Sheet: / File: rosco_m68k.sch		
Title:		
Size: A4	Date: 2020-02-25	**Rev:**
KiCad E.D.A. kicad 5.1.5+dfsg1-2bpo10+1		Id: 1/7

CPU, RAM & ROM	>DRAWING_NAME
	>LAST_DATE_TIME
	Sheet: >SHEET

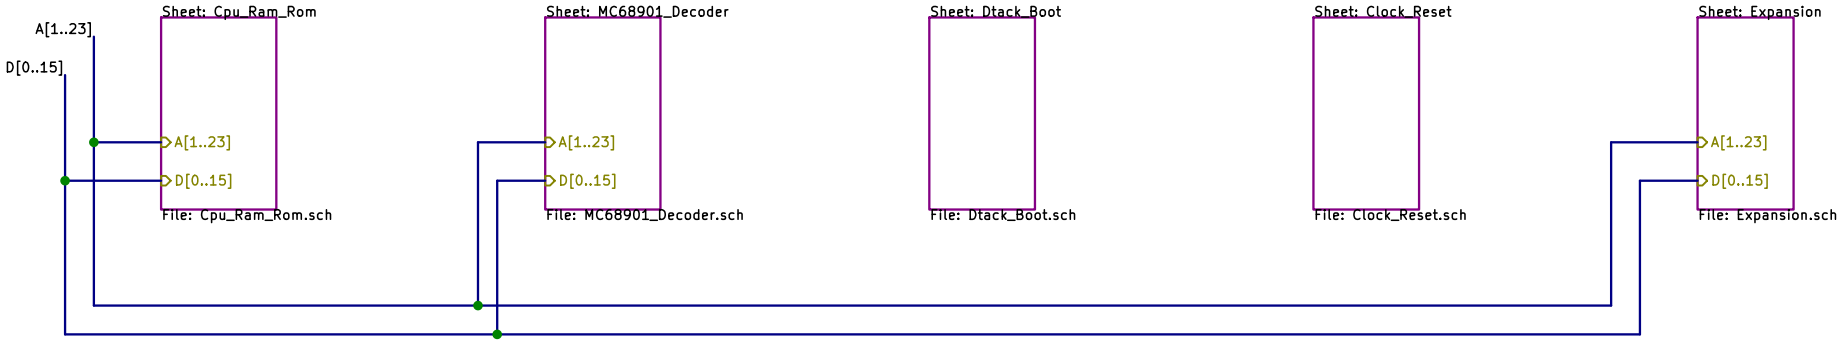
2020-02-25
Double click to enther a Hierarchical sheet.
(RMB & select from sub menu to turn back).

2020-02-25
Address and data busses are routed through the hierarchical schematic.
The Control bus is still routed via global labels, because separately named signals in busses are not implemented yet (Expected in KiCad V6)

Because the Controll bus still uses global labels, all the blue bus lines of that bus is just eye candy. KiCad just relies on the global labels.

2020-02-25
ERC in EEschem still generates a bunch of errors.
These errors are from faults in symbols, for example 2 ouput pins of different IC's connected together.

2020-02-25
After all the changes I made (and intermediate) I checked the generated connectivity from the schematic with the PCB.
I have not touched the PCB (after automatic conversion) and DRC does not give errors or unrouted connections, which almost guarantees I did not add errors to the schematic.
